## DEVELOPMENT ASSESSMENT REPORT

<b>Assessment Officer:</b>	Alex Keller
<b>Address / Property Description:</b>	Lot 806 DP 752038, No.8 Lady Penrhyn Drive, Beacon Hill Construction of 10 independent living units as housing for 'older people or people with a disability', including ancillary site works
<b>Development Application No:</b>	DA2021/0545
<b>Application Lodged:</b>	2/7/2021
<b>Plans Reference:</b>	Dwg 001 to P06 dated 25/3/2021 and 18/8/2021, drawn by <i>Vigor Master Pty Ltd</i>
<b>Amended Plans:</b>	Yes (dated 18/8/2021)
<b>Applicant:</b>	Vigor Master Pty Ltd – c/o Ivy Wang
<b>Owner:</b>	8 Beacon Hill Investment Pty Ltd

Image 2: Position of building “D” proposed positioned in the location of the approved “S” shaped driveway. Note that the existing driveways either side of “C1” and C2” (middle centre buildings) have been constructed differently to DA2009/0800 (as modified) without lawful consent. (see image 3 below)

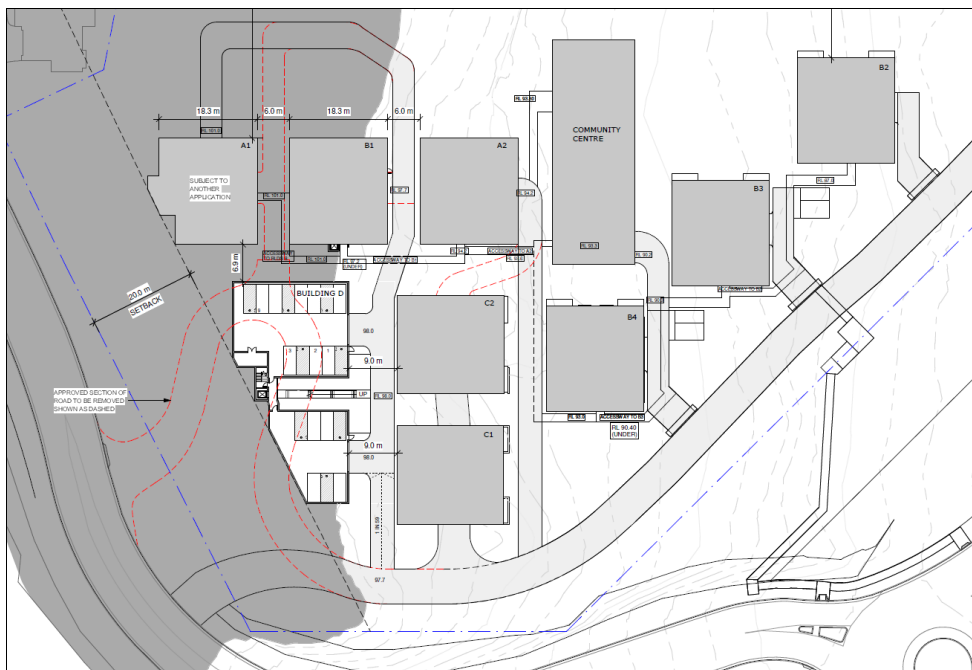
The submitted plans show the vehicle entry to the building depends on the existing unauthorised driveway along the western side of building “C1”. This driveway was built without consent and is unlawful. Therefore, planning assessment cannot support the DA as

1. Pursuant to Section 4.15 (1) (a) (i) of the *Environmental Planning and Assessment Act 1979* the proposed development application relies on unauthorised works undertaken without consent to enable vehicle access to the proposed building. The development application cannot lawfully be approved given the dependency of access on the illegal existing driveway structures and associated site works constructed contrary to the NSW LEC approval of DA2009/0800 and associated construction certificate.
